ENGINEERING PRACTICE STUDY

PROJECT NUMBER: 5961-2017-021

MIL-STD-750-2, TEST METHOD 2068:
PROPOSAL TO CLARIFY THE ACCEPT/REJECT CRITERIA
FOR NONTRANSPARENT GLASS-ENCASED, NONCAVITY DIODES
AND REFORMAT CONTENT

FINAL REPORT

FIGURE 2068-1. Nontransparent glass, double plug, noncavity diode construction (axial leads and SMD end caps shown).

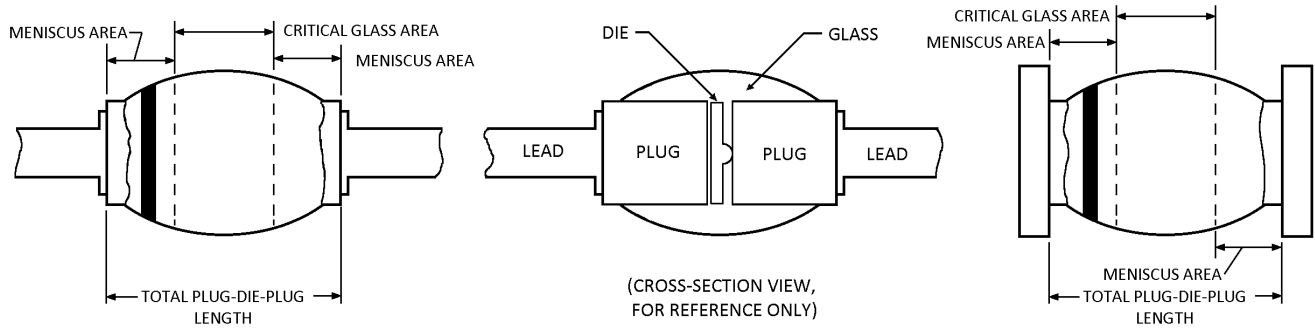
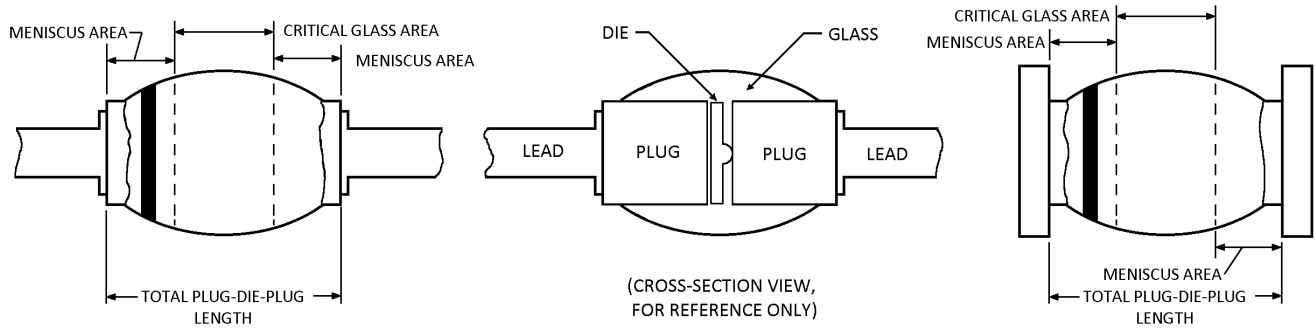
3. Definitions (see figure 2068–1). The definitions for all terms used herein shall be as specified in MIL-PRF-19500 and those contained herein. The following definitions shall apply for this test method.

- a. Critical glass area. This is the area in the central 50 percent of the total plug-die-plug length centered around the die.
 - b. Meniscus area. This area is defined as the outside edge of the body glass extending 25 percent of the total plug-die-plug length from either end.

FIGURE 2068-3. Unacceptable body glass cracks.

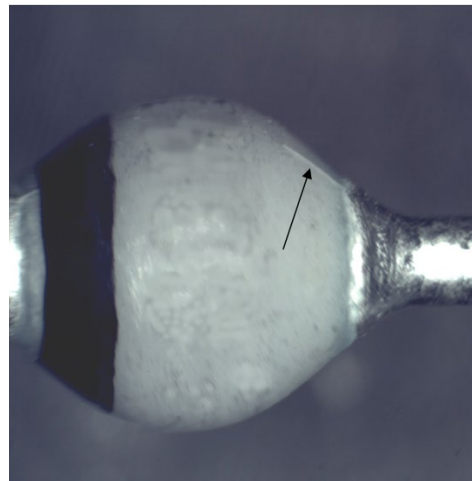
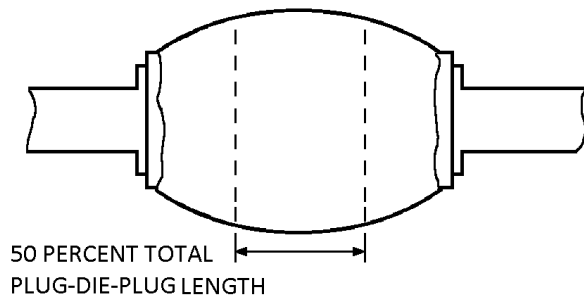
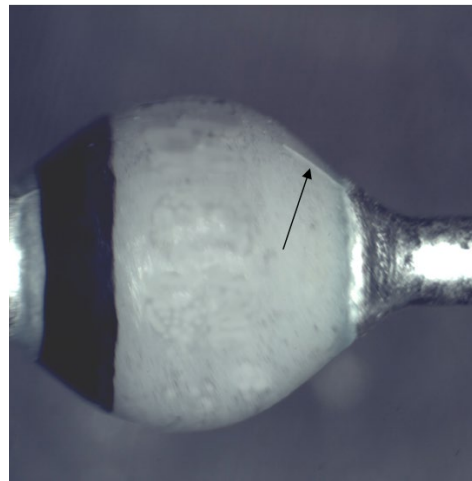
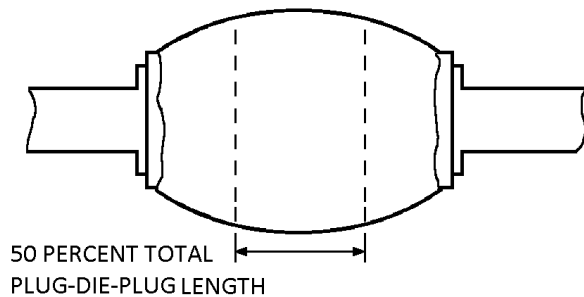
5. Failure criteria.
 - a. Cracks (see figures 2068–2 and 2068–3). Any device exhibiting cracks in the critical glass area shall be rejected. Cracks or chipouts in the meniscus area at either end of the body glass shall not be cause for rejection.

FIGURE 2068-5. Unacceptable coverage.

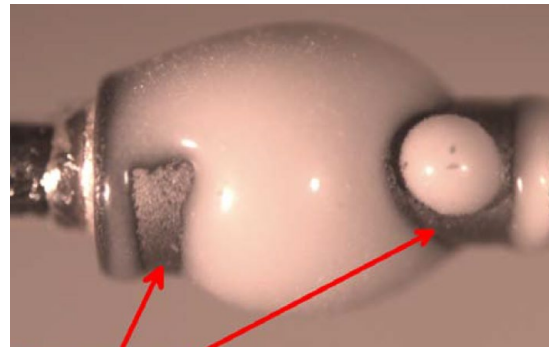
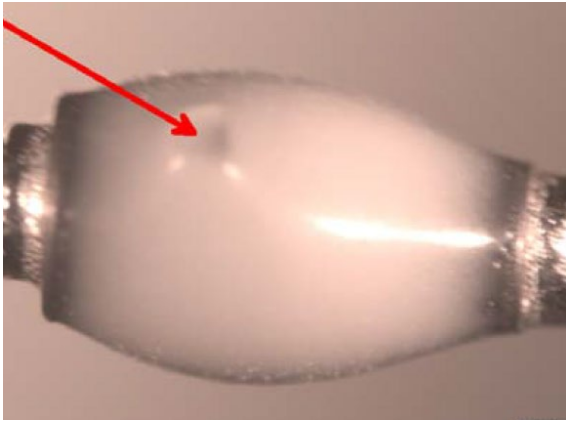
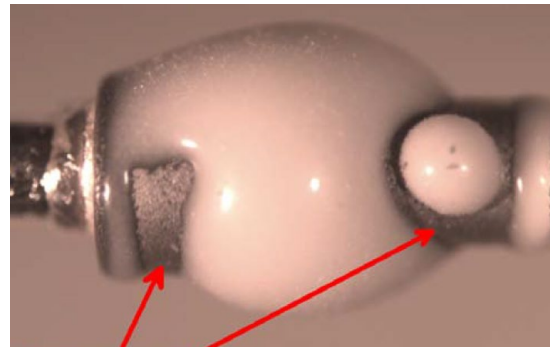
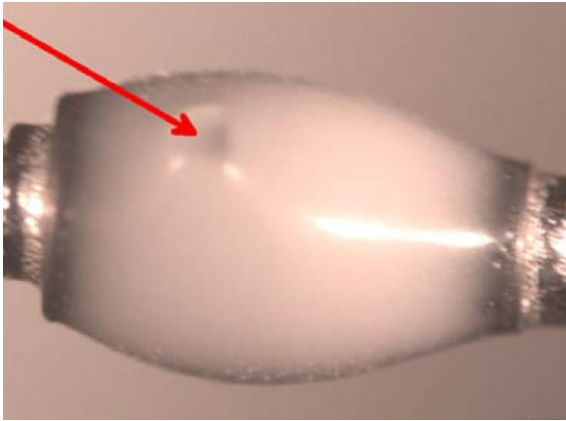
- b. Insufficient glass coverage (see figures 2068–4 and 2068–5). Any device where the body glass does not cover a minimum of 50 percent of the total plug-die-plug length shall be rejected. Any device where exposure of a plug is greater than 25 percent of the total plug-die-plug length on either terminal side shall be rejected.

FIGURE 2068–6. Acceptable depression.

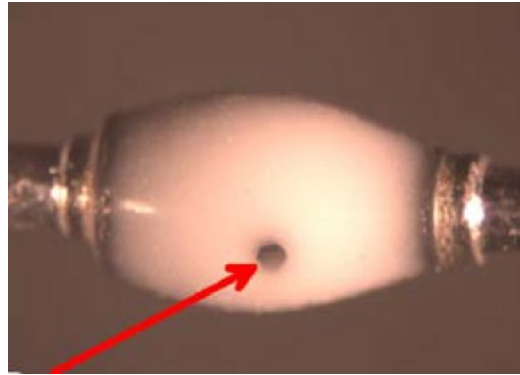
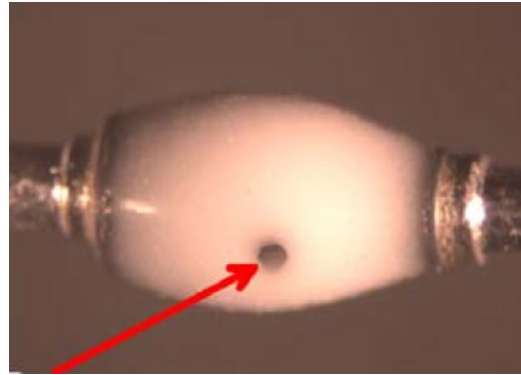
- c. Meniscus area. Glass pull-back and cracks that start in the meniscus area shall not encroach into the critical glass area.
 - d. Pin holes or voids (see figures 2068–6 and 2068–7). Any device with a pin hole or void in the critical glass area shall be rejected if it exposes the die element or the bottom of the pin hole or void is not visible.
